Washington State Convention Center Addition Project: Co-Development

Design Review Board Recommendation Meeting 02
01-16-2018

DRB#1 CONDITION OF APPROVAL RESPONSE

LEVEL 1

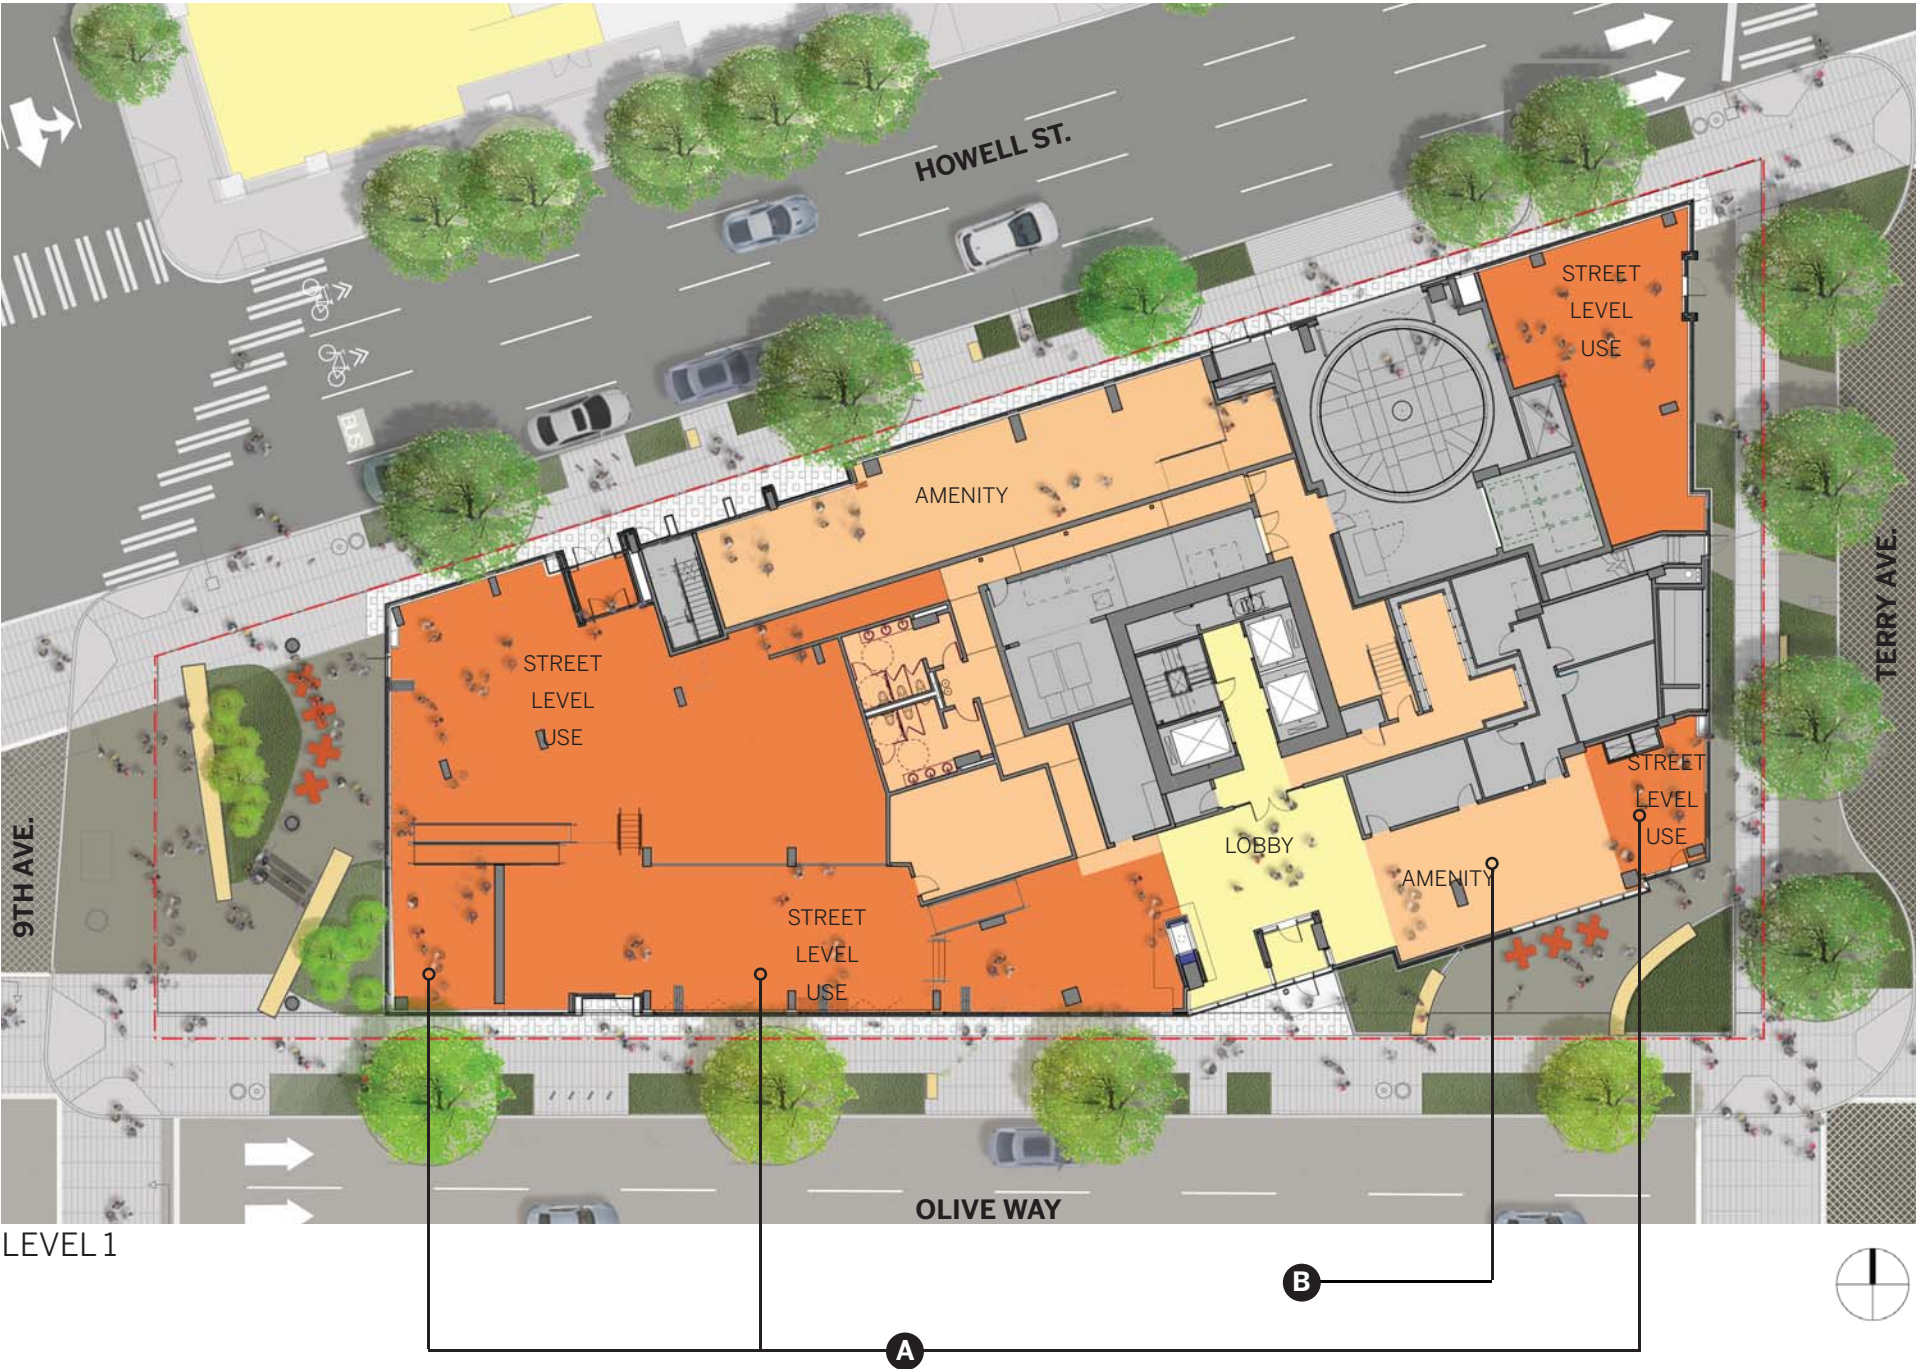
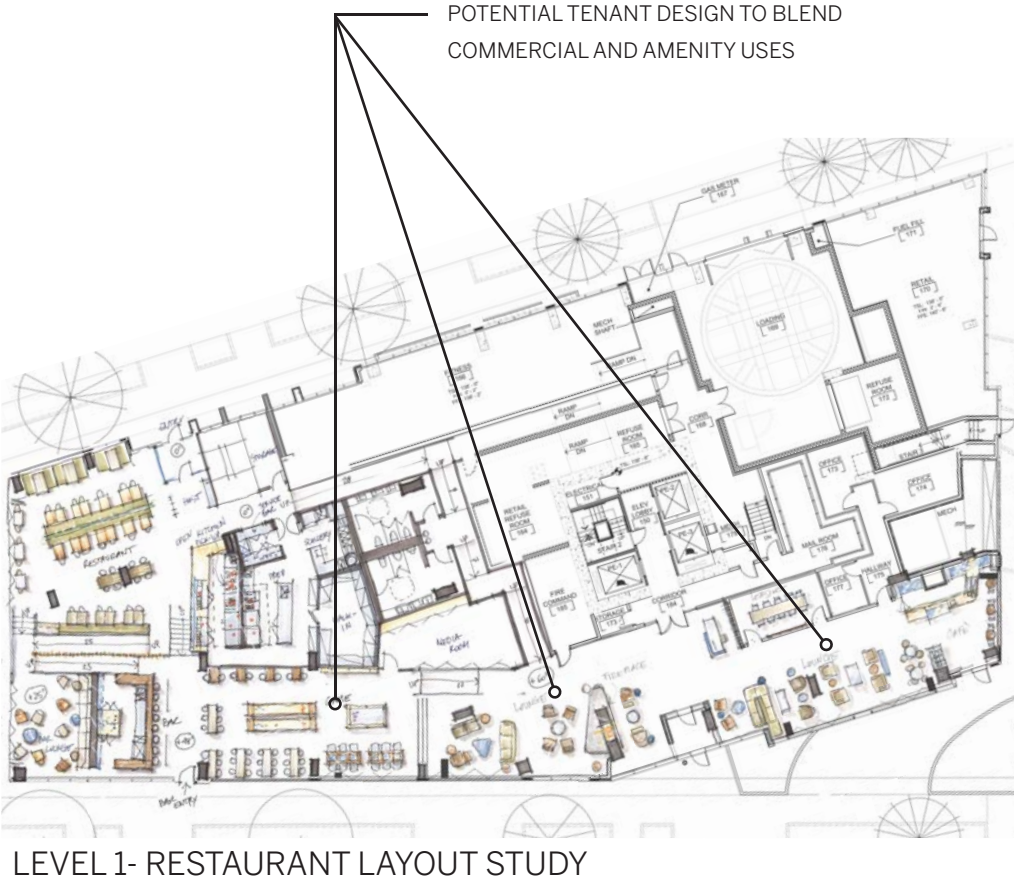
Revise the entire ground floor frontage facing Olive Way, except for the yellow lobby zone shown on pg 56, to consist of true retail/commercial uses with doors direct to the sidewalk and southeast corner plaza. These uses and area should not be counted towards any Code- required amenity area. (C1, C3, C4)

Street level-use has been proposed along Olive Way per DRB guidance. See sheet A201 in MUP (Residential Tower).

- A** - Street level-use provided along Olive Way.
- B** - Area adjacent to lobby remains amenity space needed to serve the main residential tower lobby, the space is intended to be shared with building tenants and retail space.

OLIVE WAY AND TERRY AVE. (SITE B)

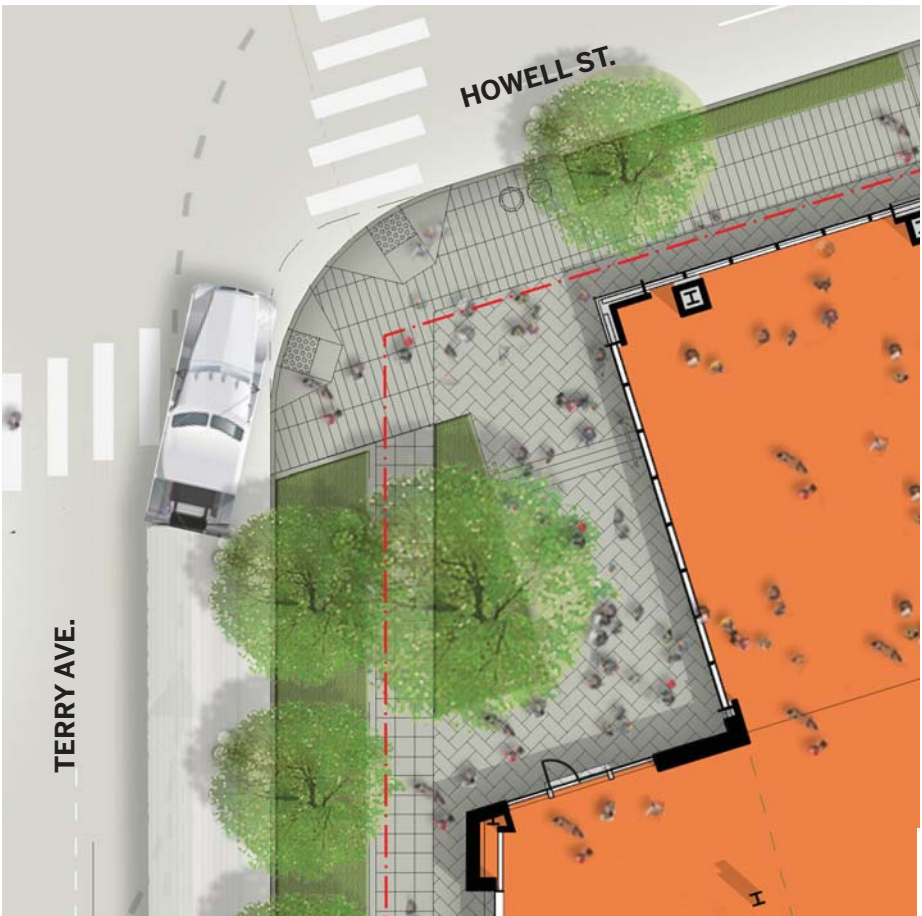
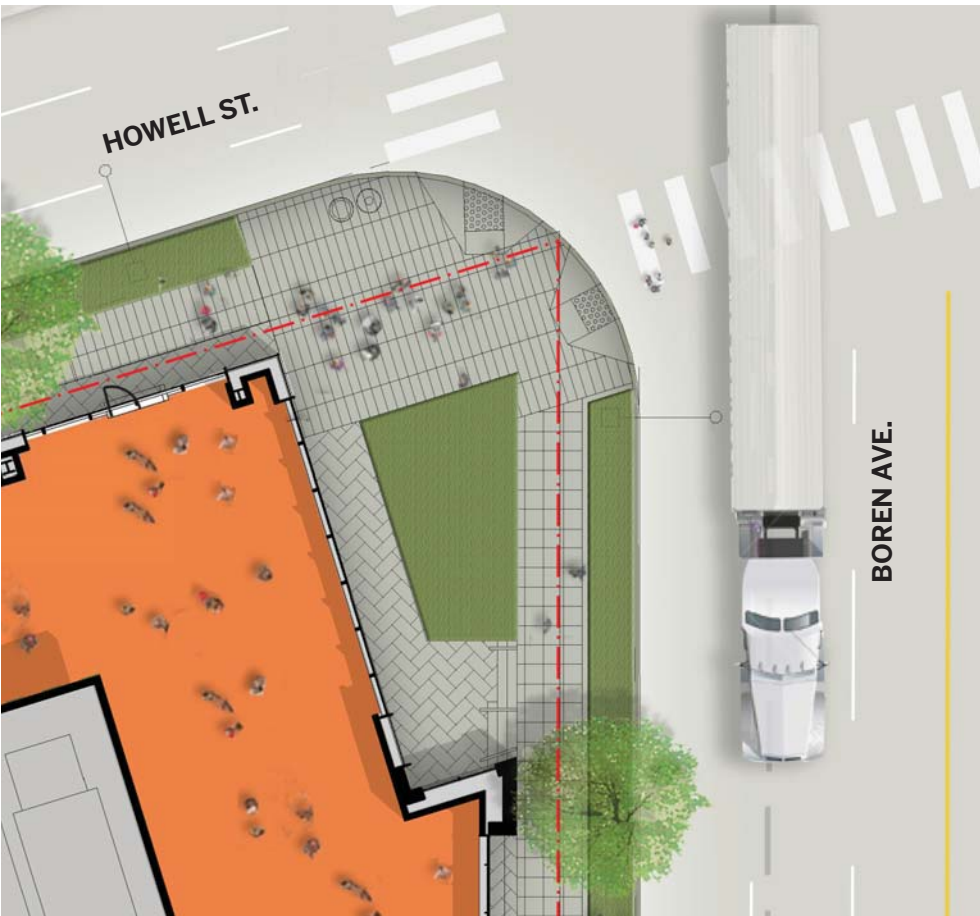
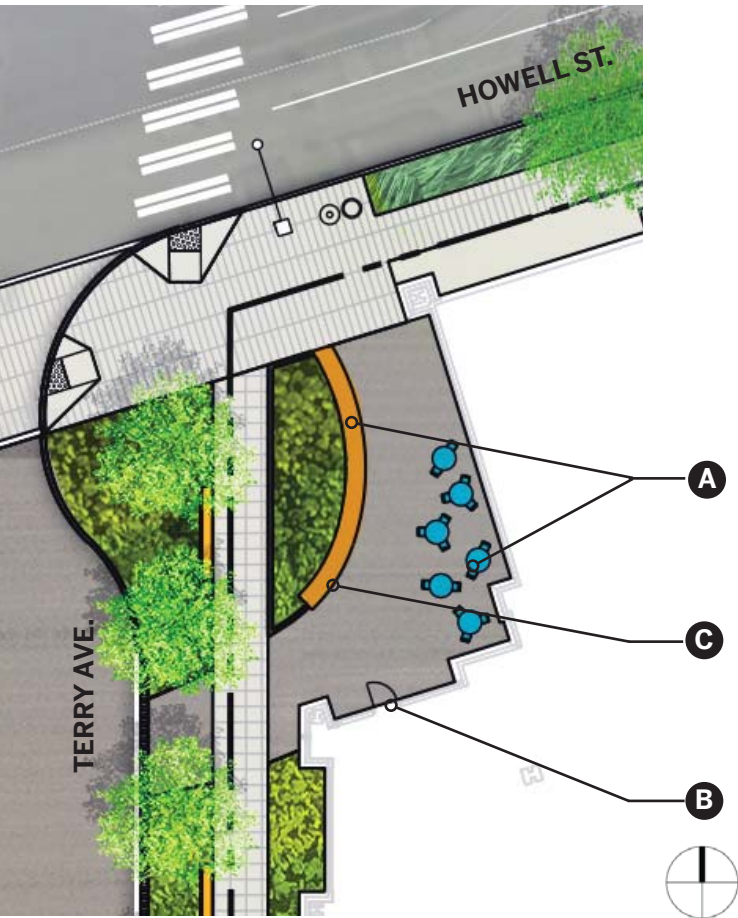
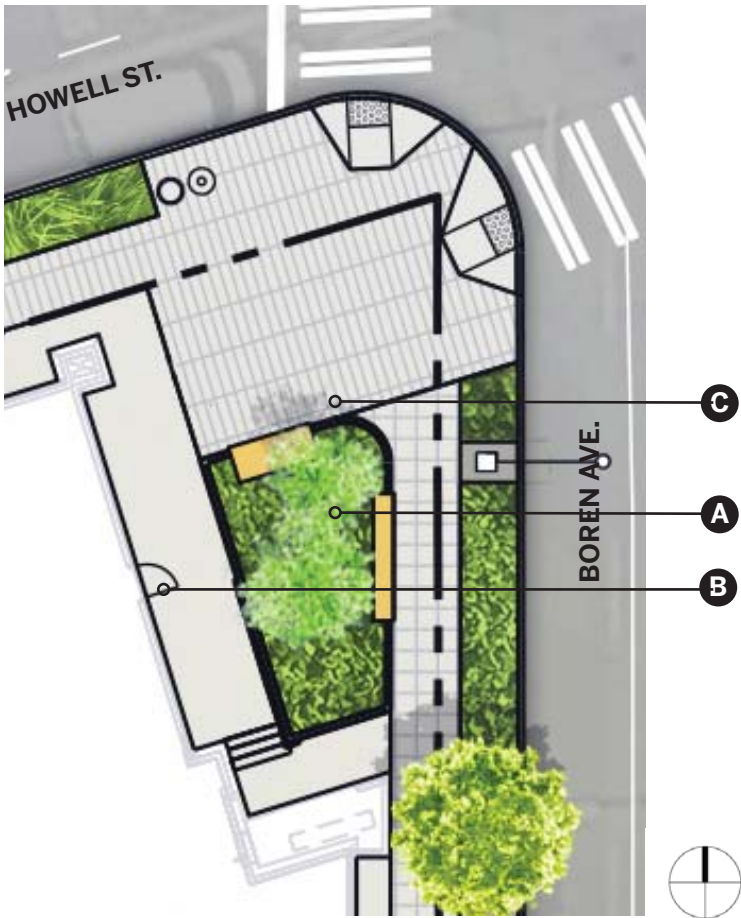
1c & 4a: Revise the design of the three plaza lawn panels to be more than simple turf, and to provide diverse pedestrian amenities such as seating, lighting and artwork. Add retail access doors directly onto the plazas to activate them. The building edge paving should be widened to facilitate the retail and doors adjacent, and the intersection corners should be eased to accommodate diagonal pedestrian desire lines. (C1, D1, D2)

The plaza landscape designs have been revised to allow for easier pedestrian flow along the building, direct access from retail doors onto the plaza when sidewalk elevations allow, activated plazas with seating and connections to the retail. See sheet L111 (Residential Tower) and sheet L111 (Office Tower) in MUP.

- A - Pedestrian amenities and seating added.
- B - Retail doors accessed directly to plaza.
- C - Corners eased to accommodate pedestrian desire lines.

SITE B: PROPOSED 9TH AVENUE PUBLIC PLAZA

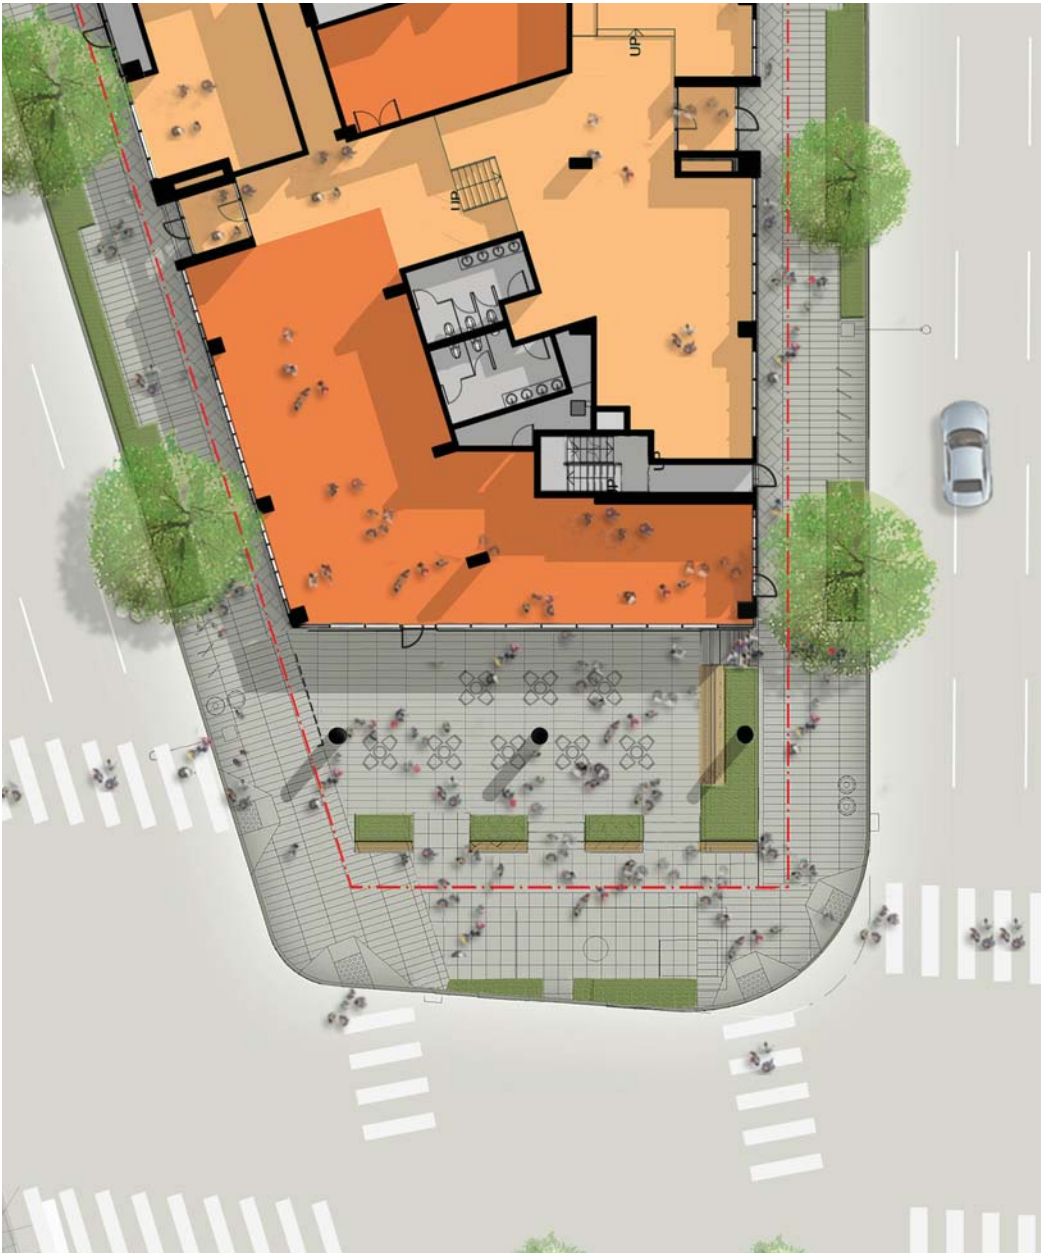
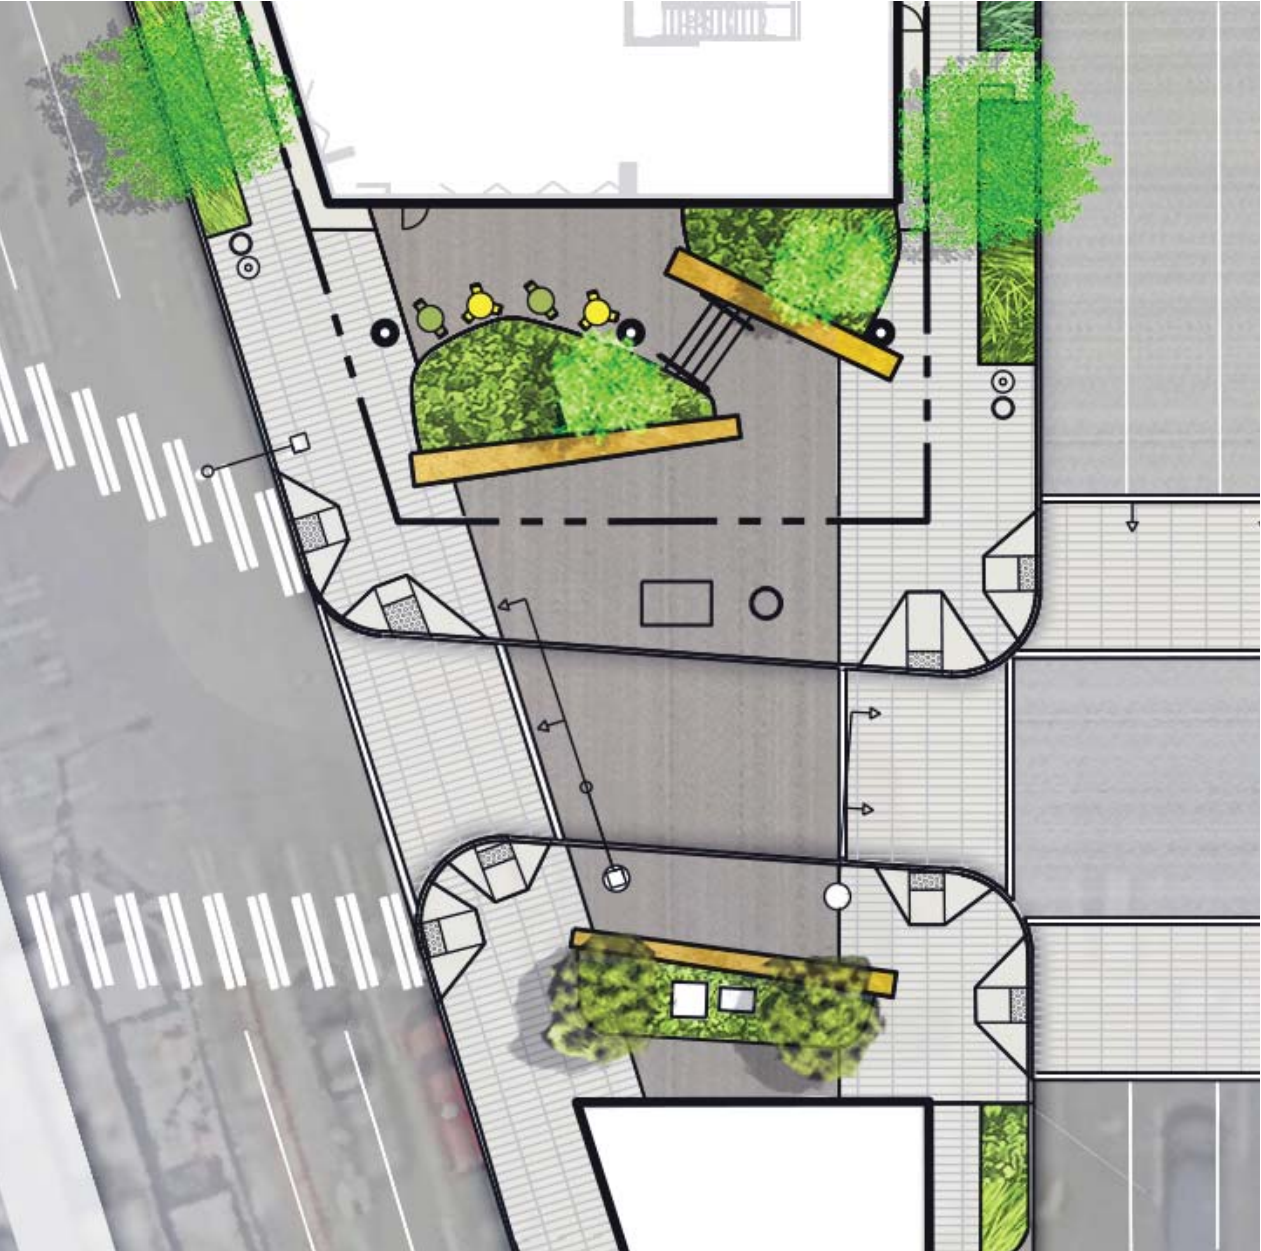
Revise the plaza design to match the basic design of the “Alternate 2” shown at the meeting, with a consistent 12ft wide sidewalk and one consolidated planter along 9th Avenue. The planter should include edge seating and 3 medium height trees that work with the fourth tree at the southwest corner to vertically define the Green Street. Any steps from 9th to the plaza should be wide and as few risers as possible, and the steps at the southwest building corner should be widened to 6ft minimum. Include a wide ground level planter at the curb edge shown in Alternate 2, with lush, vertical plantings to reinforce the Green Street, (D2, D3)

The 9th Avenue Plaza has been designated a Public Benefit Open Space. The proposed design has been approved by the Seattle Design Commission. The new design remains consistent with the Alternate 2 design with a wide sidewalk along 9th Ave, one consolidated planter, wide steps down to the plaza and edge seating. A planter at the curb edge has been eliminated as proposed utilities do not allow sufficient soil depth for healthy planting.
